# BUILDING PERMIT

This is to certify that Savi Realty LLC/Great Falls Const.  
has permission to Install an exterior egress Stair System

Located At 193 MIDDLE PERMIT #2011-01-208

**AKARI - EXTERIOR EGRESS STAIR**

1 SECTION  
1/8" = 1'-0"

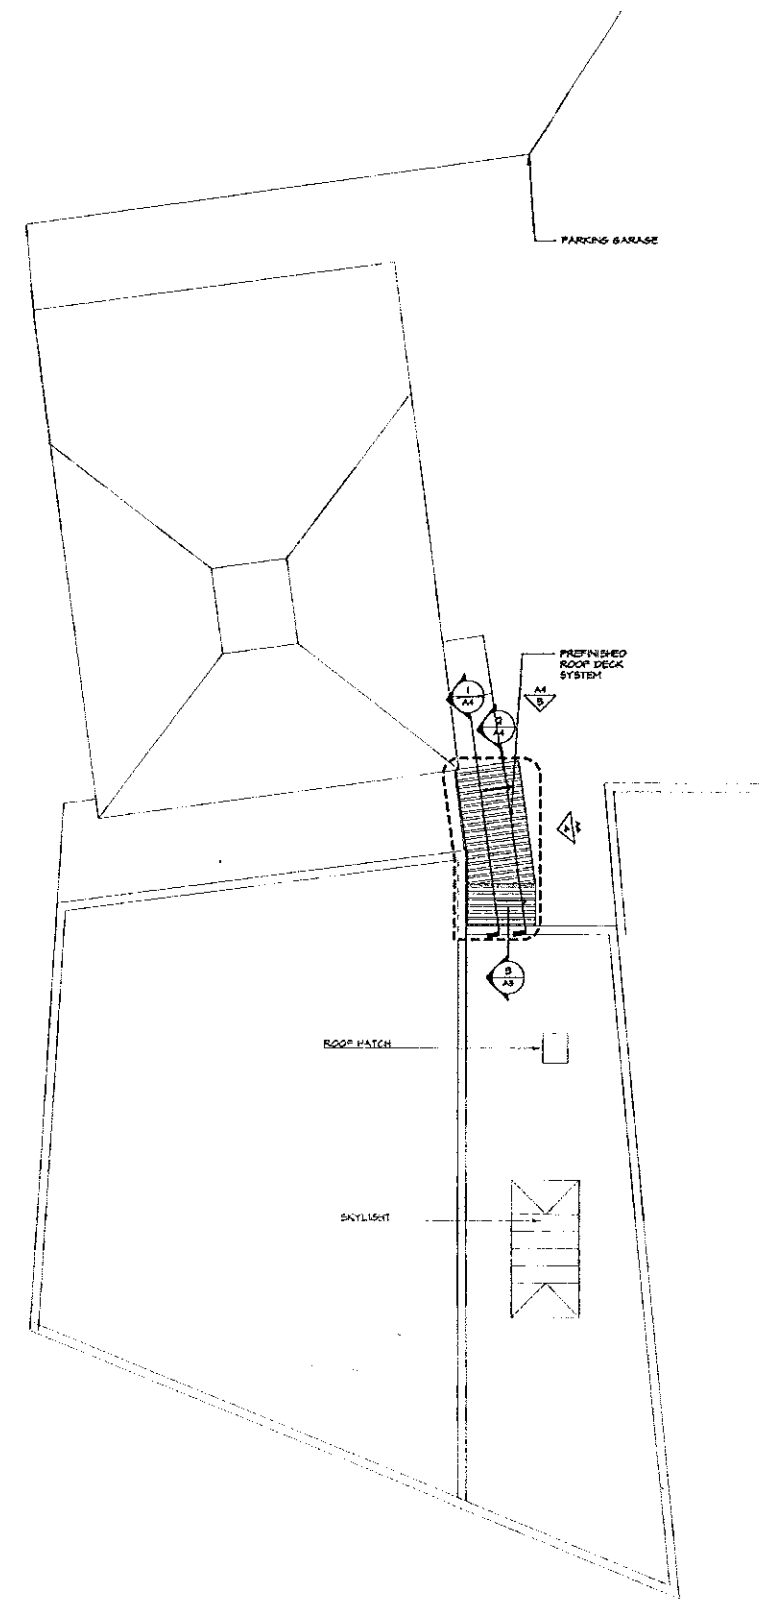
Please reference section 2/A4 to see how tight the stair already comes to the existing stairway roof. This section also shows the proper depiction of the stair re: tread-riser continuum. I've also attached a pair of details that are typical (not yet revised to specifically coordinate with the project), but show the design intent there. Please also reference 2/S1.2 for the relationship of the column at NW corner of the stair to the adjacent historic structure. The stair structure cannot be moved East to clear this, as the required 10' clearance to the neighboring (unsprinklered) building to the East is within an inch +/- tolerance as shown.
